**FEDERAL AVIATION ADMINISTRATION  
AIRWORTHINESS DIRECTIVES**

**SMALL AIRPLANES, ROTORCRAFT, GLIDERS,  
BALLOONS, & AIRSHIPS**

**BIWEEKLY 2018-03**

*1/22/2018 - 2/4/2018*

**Figure 1 to Paragraph (h) of this AD. Combustion Chamber Case Assembly**

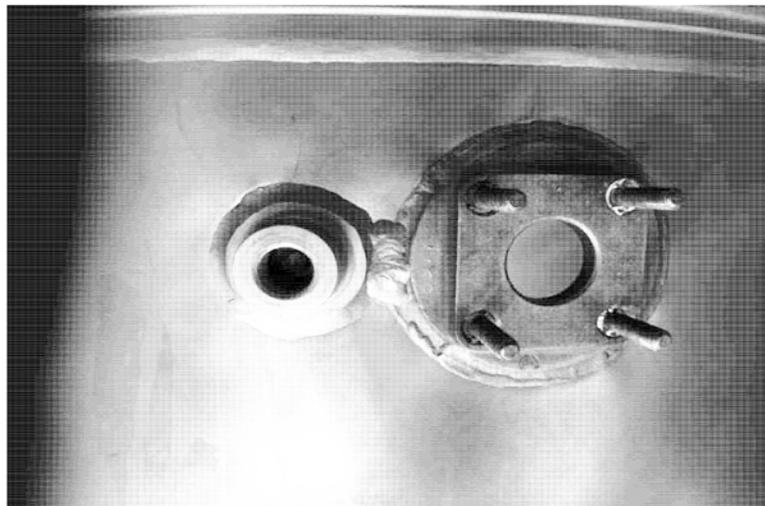
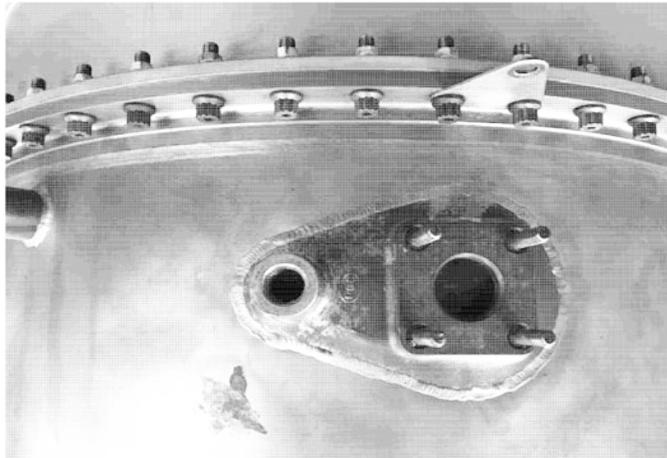
(2) For TPE331-3U, -3UW, -5, -5A, -5AB, -5B, -6, and -6A engines with combustion chamber case assemblies, P/Ns 869728-1, 869728-3, or 893973-5, installed, and without the one-piece bleed pad with P3 boss; and for TPE331-1, -2, and -2UA engines modified by National Flight Services, Inc., supplemental type certificate (STC) SE383CH, remove the combustion chamber case assembly from service at the next removal of the combustion chamber case from the engine, not to exceed 3,700 hours time-in-service since last hot section inspection.

TPE331 model engines modified by STC SE383CH may be defined as the “Super 1” and “Super 2” for the compressor modification of the TPE331-1 and the TPE331-2, -2U, and -2UA engines, respectively. Figures 1 and 2 to paragraph (h) of this AD illustrate the appearance of combustion chamber case assembly, P/N 893973-5, without and with, respectively, the one-piece bleed pad with the P3 boss.

After the effective date of this AD, do not install a combustion chamber case assembly, P/N 869728-1, 869728-3, or 893973-5, in TPE331-3U, -3UW, -5, -5A, -5AB, -5B, -6, and -6A engines or in TPE331-1, -2, and -2UA engines modified by National Flight Services, Inc., STC SE383CH, unless the combustion chamber case assembly has a one-piece bleed pad with P3 boss.
